# HARNETT CENTRAL PRESS BOX

HARNETT CENTRAL PRESS BOX  
HARNETT COUNTY SCHOOLS  
2911 HARNETT CENTRAL RD, ANGIER, NC 27501

PROJECT INFORMATION:  
DATE: 1/10/2023  
DRAWN BY: RDH  
CHECKED BY: JEL  
SHEET TITLE  
COVER SHEET  
SHEET NUMBER  
G-001  
PROJECT# 21-11110

SHEET TITLE:  
**EXTERIOR ELEVATIONS**  
SHEET NUMBER:  
**G-201**  
PROJECT# 21-1110

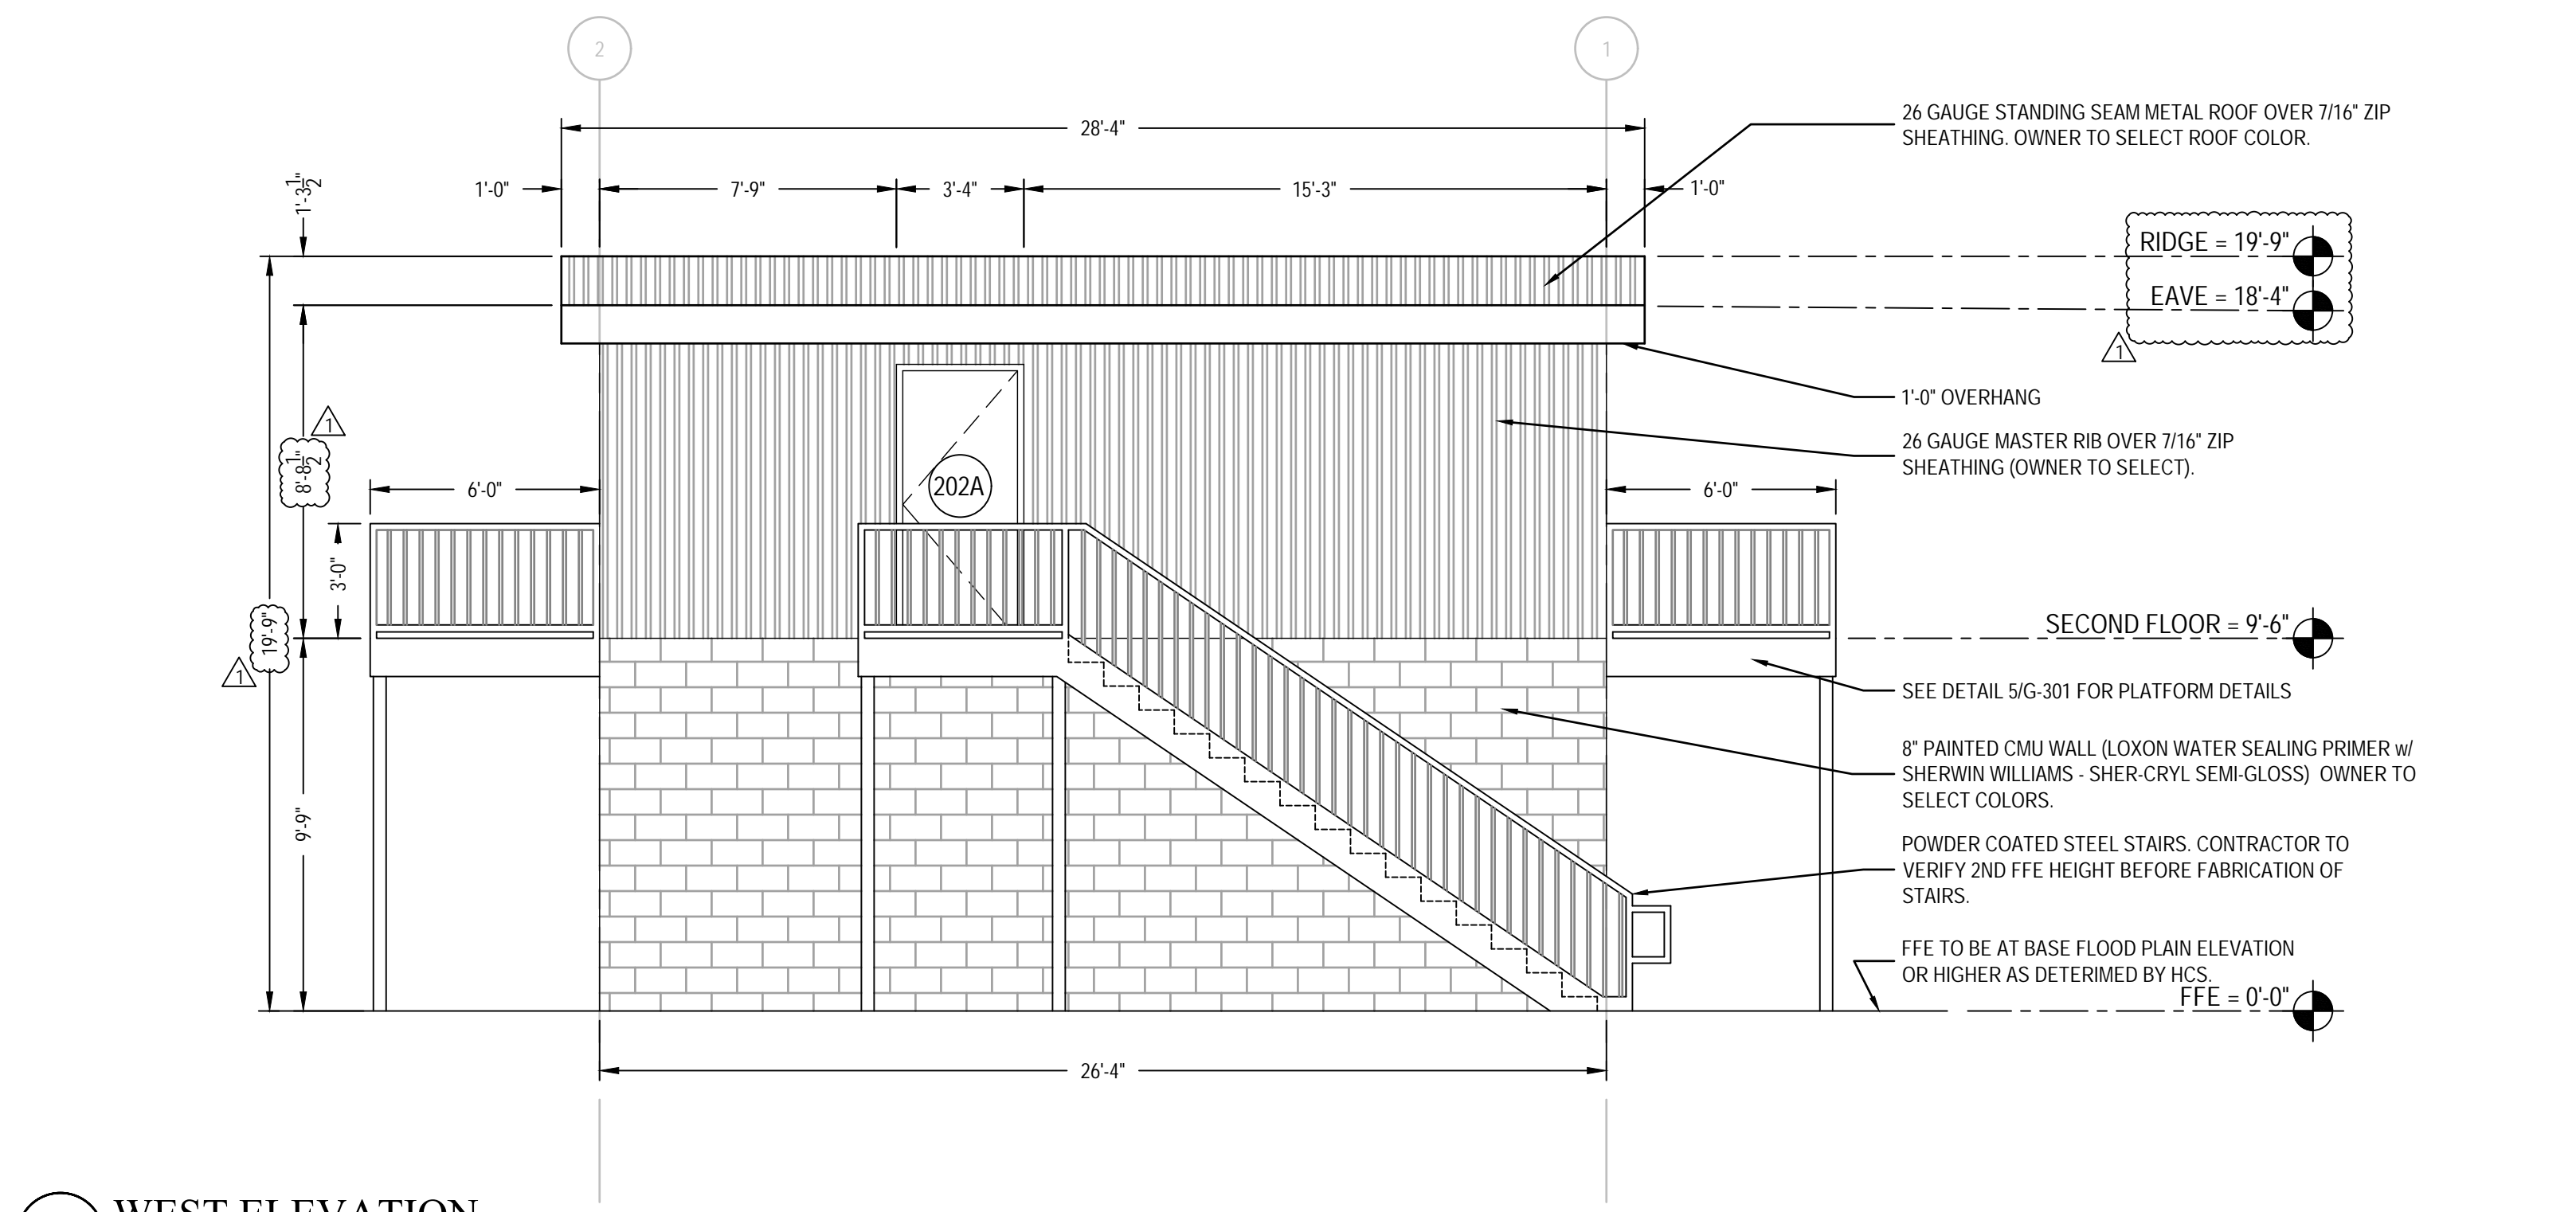
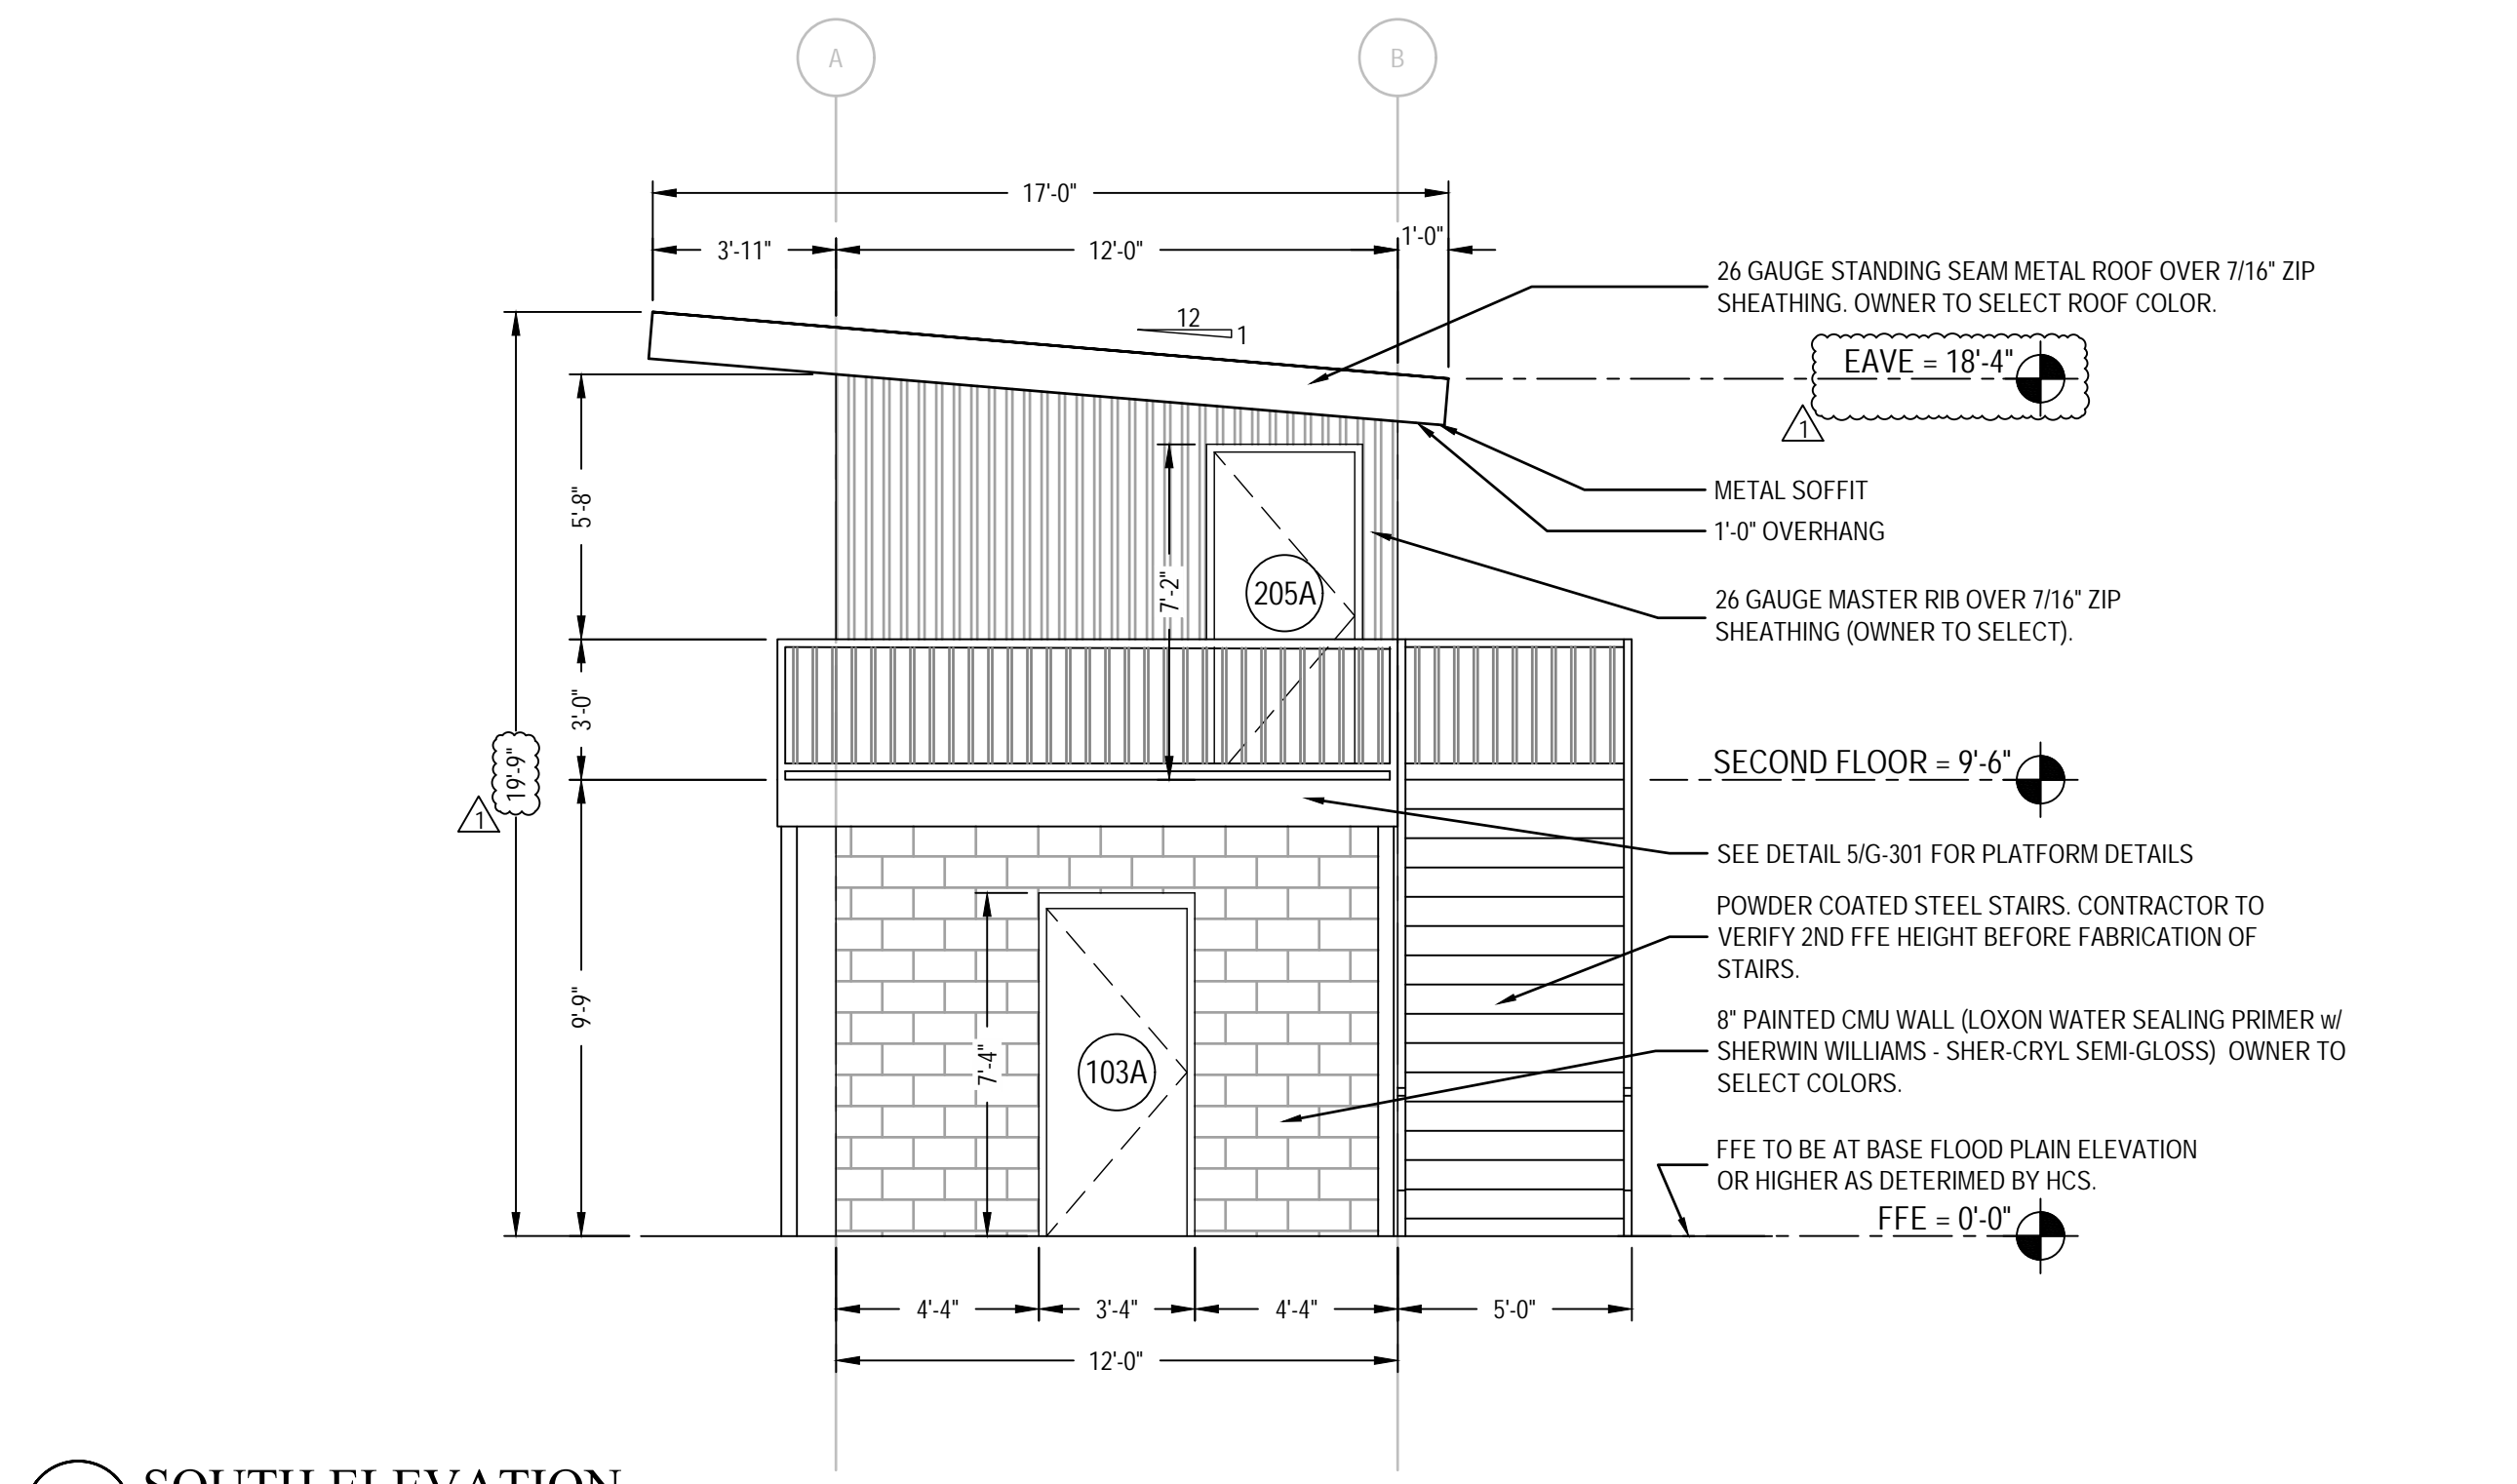
REV#	DATE	DESCRIPTION
1	4/12/2023	ROOF THICKNESS CHANGED AND ELEVATIONS UPDATED.
2		
3		
4		
5
